To: File, Taunton WWTP, NPDES No. MA0100897

From: Susan Murphy, Permit Writer

Date: March 11, 2015

Re: January 8, 2015 Supplemental Comments submitted by John Hall

Figure 22. Volume coverage as a function of temperature over the 1999 yearly simulation for various Brayton Point Station heat loads: MOA II (current operating condition), EMM (reduced heat operating condition), and no-plant operating scenarios.

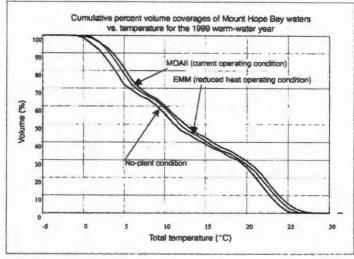
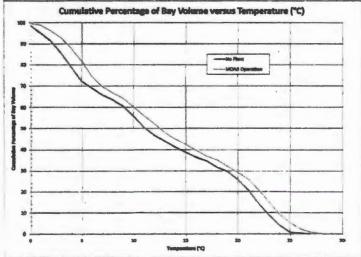
The temperature impacts noted in the 2015 memo from Swanson are the same as those presented in this 2006 article, see comparison of charts below. The one from the article shows 2 operating conditions and starts at  $-5^{\circ}$  C but is substantively the same as the one we just got:

Plan view daily mean water-column temperature for no-Plant hydrothermal model run on August 1, 1999.

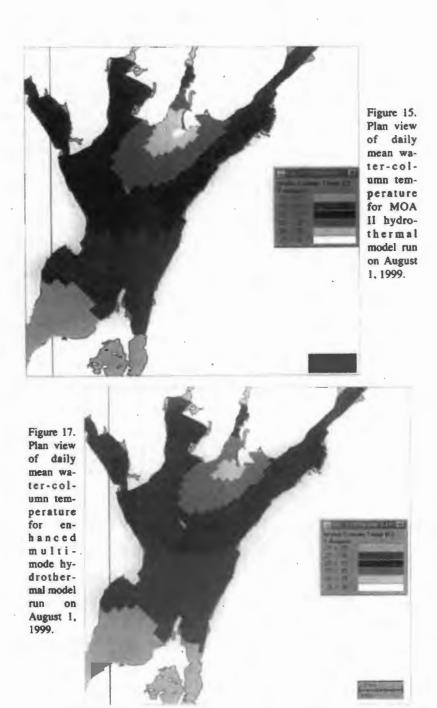
- 8. The thermal plume did not affect Taunton River temperatures. Swanson, 2006 at 153. Taunton River naturally has warmer temperatures than lower Mount Hope Bay. Swanson, 2006, Figure 19. Temperatures in the lower Bay with the thermal plume were actually similar to natural temperatures in the Taunton River. See Swanson, 2006, Figures 15 and 17. So the thermal conditions in 2004-06 actually made lower Mount Hope Bay more comparable to the Taunton River and the thermal studies do not indicate need to correct for impacts of eliminating the thermal plume if any could be shown.

Figure 20. Plan view of surface temperature differences for the EMM hydrothermal model run relative to the no-plant run at maximum ebb. Vertical cross-sectional view from the outfall is seen in the insert.

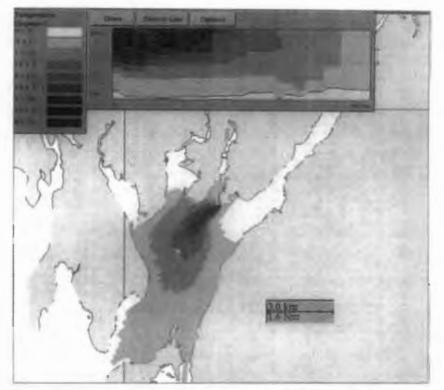
- 6. The temperature impact from eliminating the thermal plume is much less in bottom waters than the bay average (based on plume cross-sections in Swanson, 2006, Figures 20 and 21) so actual temperature difference (and related change in DO saturation) in the bottom waters where critical DO conditions exist is much less than suggested in the memo.
